Interactive comment on “Development of a Spatial Hydrologic Soil Map Using Spectral Reflectance Band Recognition and a Multiple-Output Artificial Neural Network Model” by Khamis Naba Sayl et al.

Khamis Naba Sayl et al.

Received and published: 10 April 2017

Fig. 1. Structure of Radial Basis Function Neural Network

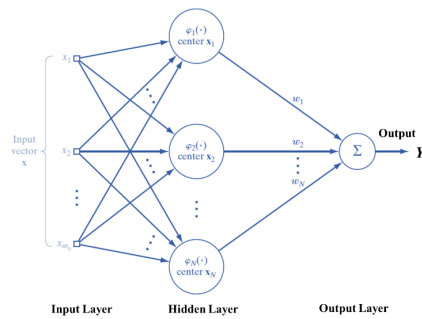
Reviewer #2: General Comments 1) Clarity of methods section, as written, the methods section is not repeatable. Much effort is needed to more specific in describing steps taken and cite all algorithms used. Couple examples: 1- soil sampling technique (e.g. auger, open pit) and sampling depths were never specified, 2- radial basis neural

network has no citations, 3- the unsupervised classification method is not specified or cited, and the software used not specified. There are quite a few major methodological details where I got lost and could not figure out what was done (please see the commented pdf for full details. Reply: The authors agree with the reviewer that more description on the methodology should be included in the manuscript. Therefore, the following paragraph that gives more details on soil sampling will be added to the revised manuscript: “There are twenty five (25) sampling locations throughout the study area. The selection of these sampling locations was made based on its accessibility, vegetation cover, the spectral signatures urban areas, water, slope, roads, soil roughness, location and topography. On-site, a GPS instrument was used to locate the sampling points. The soil samples were collected using auger and the depths were between 20 to 40 cm of the topsoil. Subsequently, the soil samples were brought to the laboratory for particle size distribution analysis. This analysis was done to determine the soil texture, which is an important parameter for hydrological behavior of soil. Particles above 50 μm were separated using wet sieving techniques, while small particles were analyzed using hydrometer method (Ryan et al. 1996; Skopp 2000). Soil particles are dispersed in water and the reduction of fluid density due to setting is determined through hydrometer (Skopp 2000). The particle size distributions of all collected soil samples were classified according to the USGS method texture classification.

The following paragraphs will be added in order to provide more details on the neural network and unsupervised classification process performed in this study: “Image classification method was used in order to extract the most relevant information needed to achieve the objectives of this study. This technique includes the process of sorting pixels into a finite number of classes or categories of data based on their data file values (Jain 1989) If a pixel satisfies a certain set of criteria, then it is assigned to the class that corresponds to that set of criteria. A pixel may be characterized by its spectral signature, which is determined by the relative reflectance in the different wavelength bands. Multispectral classification is an information-extraction process that analyzes these spectral signatures and then assigns pixels to categories based on similar signa-

tures. One form of classification is unsupervised classification (Acharya et al. 2005). Unsupervised classification was carried out using the ERDAS Imagine software and it involves the identification of clusters or groupings in a feature space. A cluster is a set of points in the feature space where their local density is large (relative maximum) compared to the density of feature points in the surrounding region. Unsupervised classification permits an unbiased assessment of the total of the raw data. It can be used on the first hand to identify the main classes and then check the information in the field (Richards and Jia 1999). This method is preferred if area is very large and field data is lacking. It illustrates that a priori knowledge of the human observer is needed to assign the pixels to classes. One of the most known unsupervised classifier method is the Iterative Self Organizing Data Analysis (ISODATA). ISODATA is an iterative process where it repeatedly performs an entire classification (outputting a thematic raster layer) and recalculates the statistics. Self-Organizing refers to the way in which it locates clusters with minimum user input (Acharya et al. 2005). Each iteration calculates means and reclassifies pixels with respect to the new means. Iterative class splitting, merging, and deleting are done based on the input threshold parameters. All pixels are classified to the nearest class unless standard deviation or distance threshold is specified. One of the primary advantages of unsupervised classification is many of the classes are created automatically (Jain 1989)” The following information on Radial Basis Neural Network (RBNN) will be added to the revised manuscript: “Radial Basis Neural Network (RBNN) is an artificial method that based on the interpolation of a multivariate function (Lowe and Broomhead 1988) . RBNN consists of three layers, i.e. input layer for feeding feature vector to the network, hidden layer where the calculation of outcome of basis function is processed, and finally the output layer for linear combining the basic functions. The following figure shows the structure of RBNN.

output space. The radial basis functions $\varphi_1, \varphi_2, \dots, \varphi_N$ are known as hidden functions while $\{\varphi_i(x)\}_{i=1}^N$ is called the hidden space. The number of basic functions (N) is typically less than the number of data points available for the input data set. Among several radial basis functions, the most commonly used is the Gaussian, which in its one-dimensional representation takes the following form: $\varphi(x, \mu) = e^{-\frac{1}{2d}(\frac{x-\mu}{d})^2}$ where μ is the center of the Gaussian function (mean value of x) and d is the distance (radius) from the center of $\varphi(x, \mu)$, which gives a measure of the spread of the Gaussian curve. The hidden units use the radial basis function. If a Gaussian function is used, the output of each hidden unit depends on the distance of the input x from the center μ . During the training procedure, the center μ and the spread d are the parameters to be determined (Moody and Darken 1989). It can be deduced from the Gaussian radial function that a hidden unit is more sensitive to data points near the center. This sensitivity can be adjusted by controlling the spread d . It can be observed that the larger the spread, the less sensitive radial basis function to the input data. The number of radial basis functions inside the hidden layer depends on the complexity of the mapping to be modeled and not on the size of the data set, which is the case when utilizing multi-layer perceptron ANN. Moreover, RBNN has the ability to recognize a complex relation between the input and output of the model. This research identifies the relationship between the bands and soil types. RBNN model requires some important parameters to be established before perform the training process, such as the performance goal of 0.0005 and the spread constant of 1."

Fig. 2. Topography of the location used to generate digital soil map and DEM of the study area generated from Shutter Radar Topographic Mission data

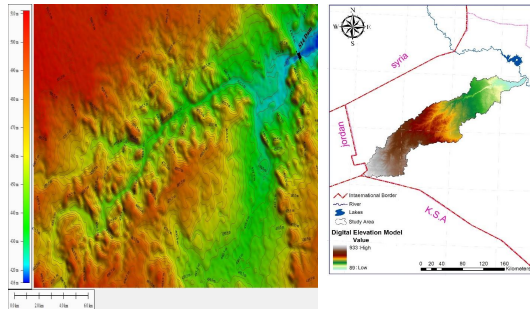
3a) Overall grasp of literature review and breadth of topics covered and utilized suggest that authors should consider expanding the tools and data they use for making these predictions (beyond having a better sample). For example, in the broad body of digital soil mapping studies, topographical layers from DEM, climate surfaces, and other spectral data (e.g. gamma radiometrics) are often the most effective predictors. I think including DEM variables could prove very effective at this scale, yet this was not done.

Reply: The authors agreed with the reviewer that including DEM variables could be very effective at this scale. Also, climate surface, and other spectral data are the most effective predictors. The authors considered the topographical layers from DEM, the Normalized Difference Vegetation Index (NDVI) in dry and wet season, and climate data as shown in line 128. These data extracting techniques are well known and commonly used in research (Cvar 2014; Sayl et al. 2016). The following paragraphs will be added to give more information on the tools and data used in making these predictions (beyond having a better sample): “The DEM generated from Shuttle Radar Topographic Mission SRTM data was used to present the topography of the study area (as shown in Figure 2 below), slope data and drainage. The earth features, such as the Normalized Difference Vegetation Index (NDVI) is used primarily for vegetation identification and to determine the lushness of vegetated land surfaces (using ERDAS Imagine software). These features were considered in this study as a basic guide during the field work. In addition, the location of the points used to generate digital soil map were selected according to DEM generated for a small area in order to overcome the problem of scale”.

Fig. 3. Location of sampling areas

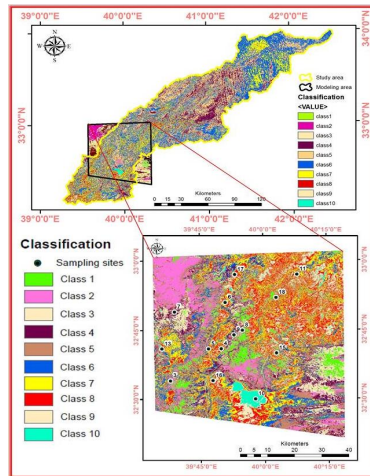
20) Line 129 p.4 – Also need a subset map showing the location of the sampling area relative to the larger study area? Reply Please refer to Figure 3
